RECOMMENDATION MEETING (#3034058-EG)

August 28, 2020

1766 NW MARKET STREET, SEATTLE, WA 98107

Construction of a new 85' eight story Type IV-C mass timber (CLT) hotel. With six floors of 120 upscale guestrooms, a double height CLT jewel box amenity at the ground floor with outdoor open space, a roof deck for hotel guests, and one floor of below grade parking with 30 stalls. The main hotel entrance will be located on the southeast corner of the site on NW Market St, and an outdoor dining area to the southwest. Access to the below grade parking levels will be from the alley to the North.

TYPE 1 DECISION REQUEST - PARKING ACCESS SLOPE

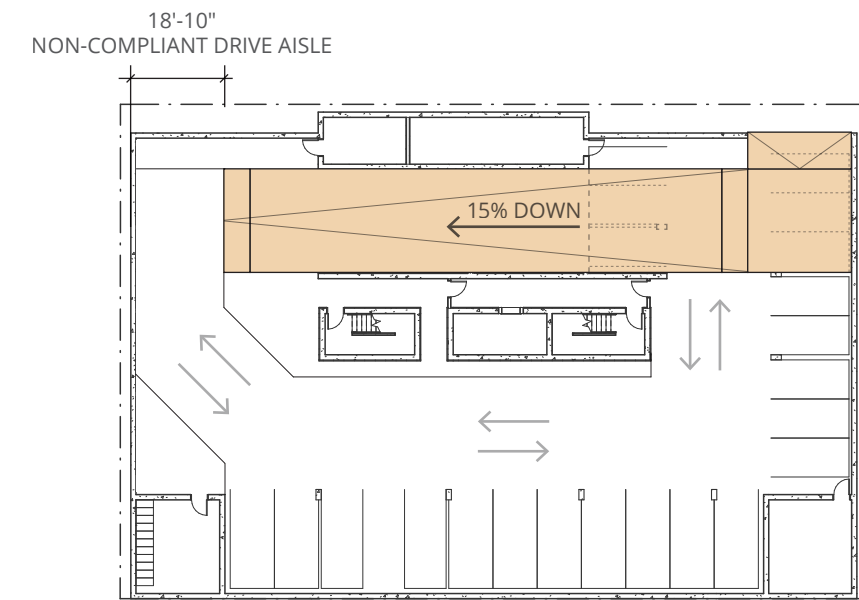
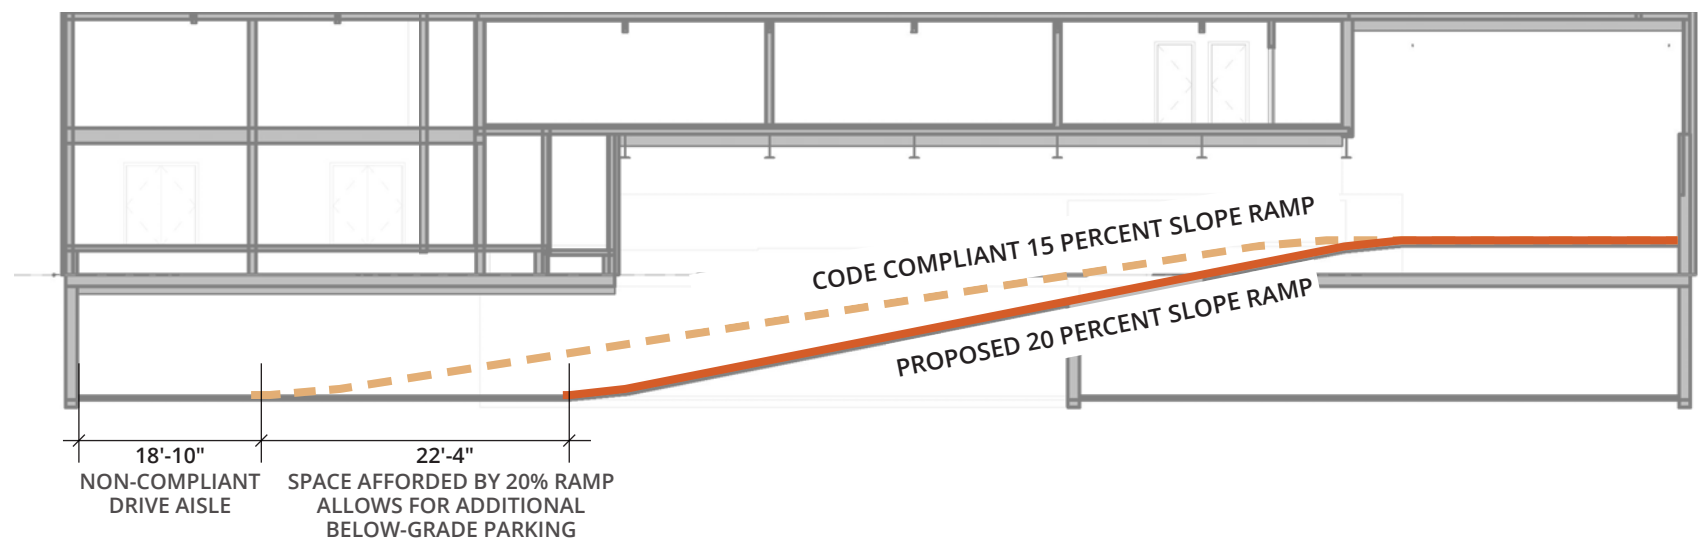
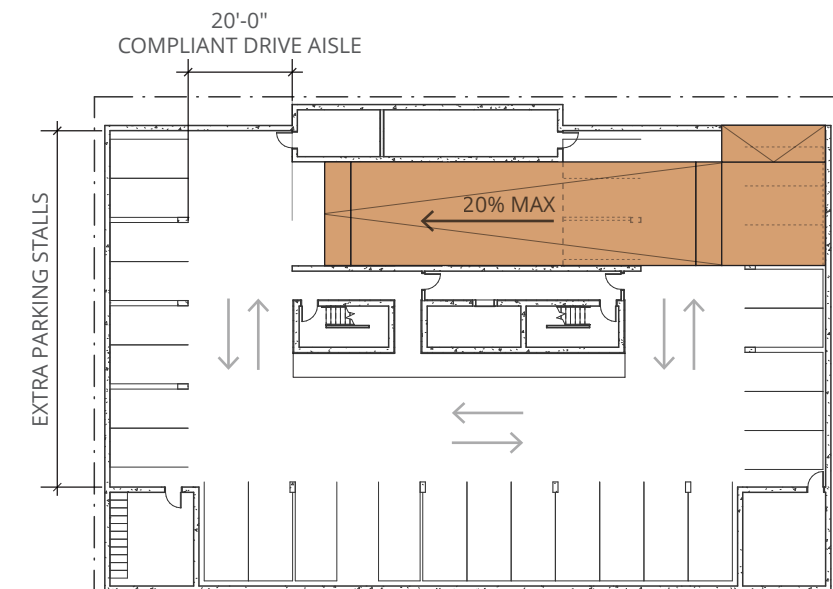
PERMITTED SLOPE SMC 23.54.030.D.3 Driveway slope for all uses. No portion of a driveway, whether located on a lot or on a right-of-way, shall exceed a slope of 15 percent, except as provided in this subsection. A maximum 15 percent slope shall apply in relation to both the current grade of the right-of-way to which the driveway connects, and to the proposed finished grade of the right-of-way if it is different from the current grade. The ends of a driveway shall be adjusted to accommodate an appropriate crest and sag. The director may permit a driveway slope of more than 15 percent if it is found that:

PROPOSED SLOPE 20% maximum slope with 10% crest and sag ends.

RESPONSE Even though there is an existing curb cut along NW Market Street that accesses a parking lot, SDOT is requiring the below-grade parking to be accessed from the alley. The grades along the alley are in excess of 3' higher than the grades along NW Market Street. The length of a code-compliant ramp needed to access a below-grade parking level would greatly reduce the number of parking stalls due to the length of the lot and would result in non-complaint drive aisle dimensions within the parking structure. Although parking is not required on site, it is an important component of the development, to mitigate the impact of added parking on the surrounding residential and neighborhood.
